DOCUMENT CHANGE REQUEST

DCR number 372 Changes required for: General

Title: Transistors High Power NPN, based on types 2N3439 and 2N3440

Number: 5203/011

1.6.1 Metal Can Package (TO-5) - 3 lead

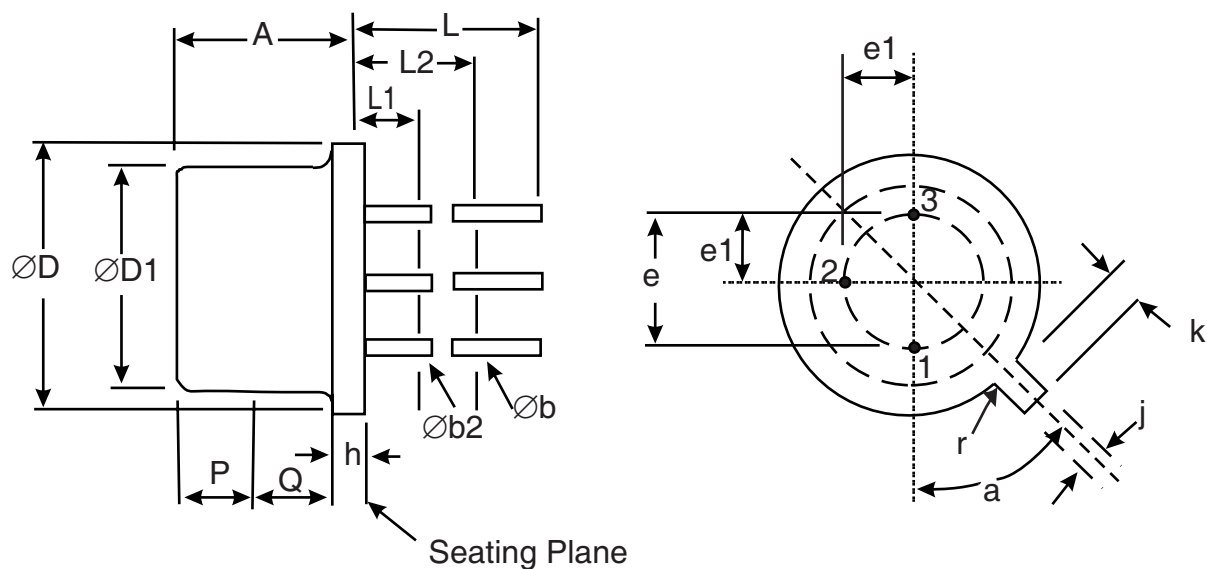
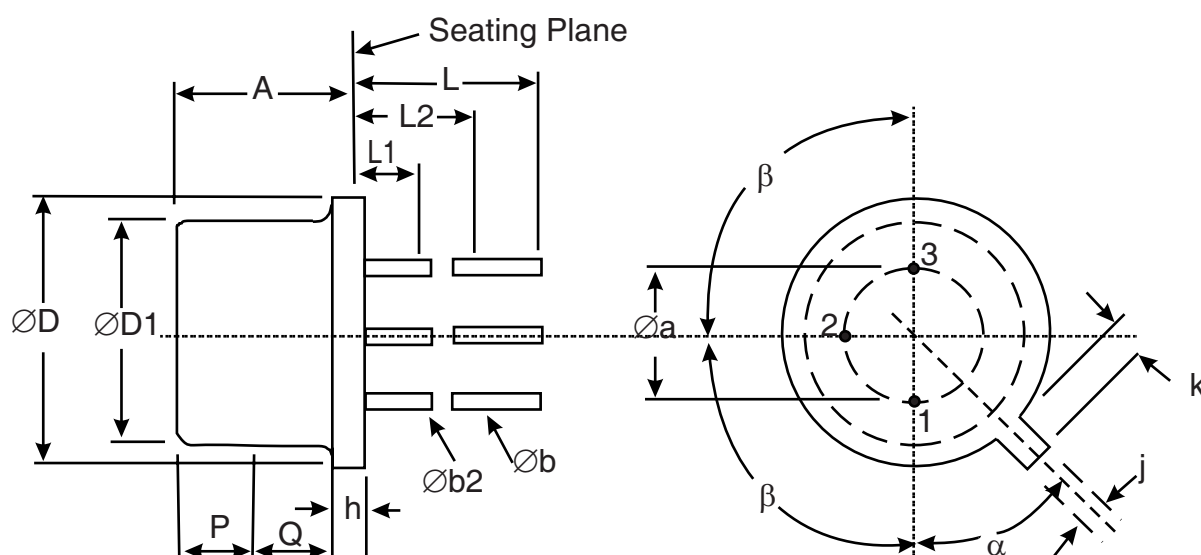
7. Para. 4.3.2 Weight requirements moved to Component Type Variants table.
8. Figure 2 re-named "Physical Dimensions and Terminal Identification"; Figure 2(a) amended to reflect the TO-5 package currently supplied; Figure 2(b) amended to reflect the TO-39 package currently supplied.

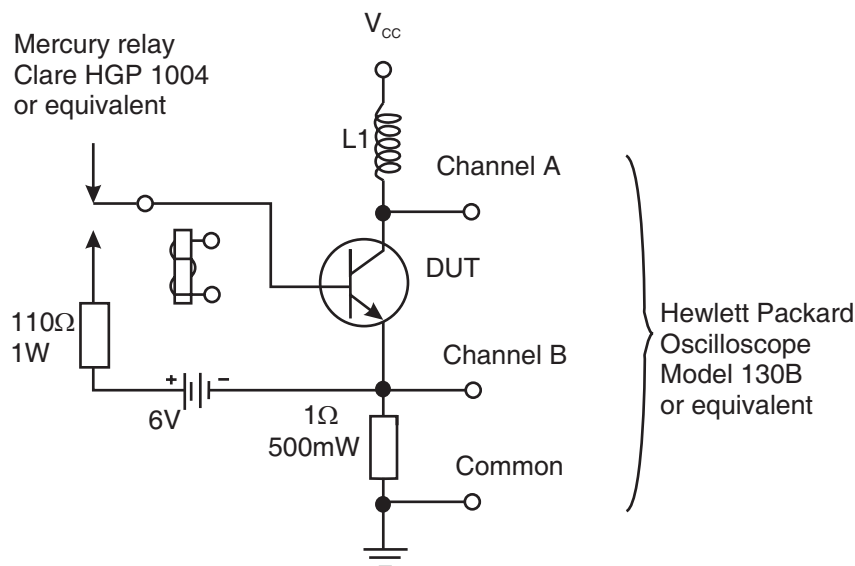
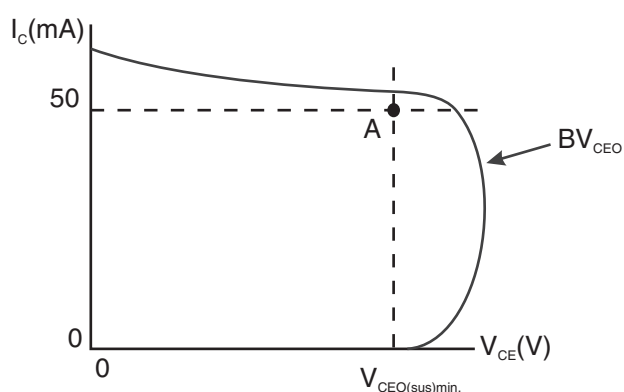
23. Tables 2, 3 and 4 - Test Conditions column: addition of Test, or Bias, Conditions for referenced MIL-STD-750 Test Methods as and where applicable.
24. Figure 4 amended and moved to be a note (Note 4) to Room Temperature Electrical Measurements.

1. Pulsed measurement: Pulse Width $\leq 300\mu s$, Duty Cycle $\leq 2\%$.
2. Saturation voltage is measured 6mm from the case.
3. For AC characteristics read and record measurements shall be performed on a sample of 32 components with 0 failures allowed. Alternatively a 100% inspection may be performed.
4. $V_{CE(sus)}$ shall be measured using the test circuit shown below. $V_{CC} = 0V$ to 60V, pulsed, Pulse

Width $\leq 300\mu\text{s}$, Duty Cycle $\leq 2\%$. $I_{CC} = 100\text{mA}$. Inductor L1 shall have the following characteristics:
 $L = 25\text{mH}$, $Q = 76$, $R = 83.4\Omega$, $I = 75\text{mA}$.

BV_{CEO} is acceptable if the trace is both to the right of, and above, point A, as shown.
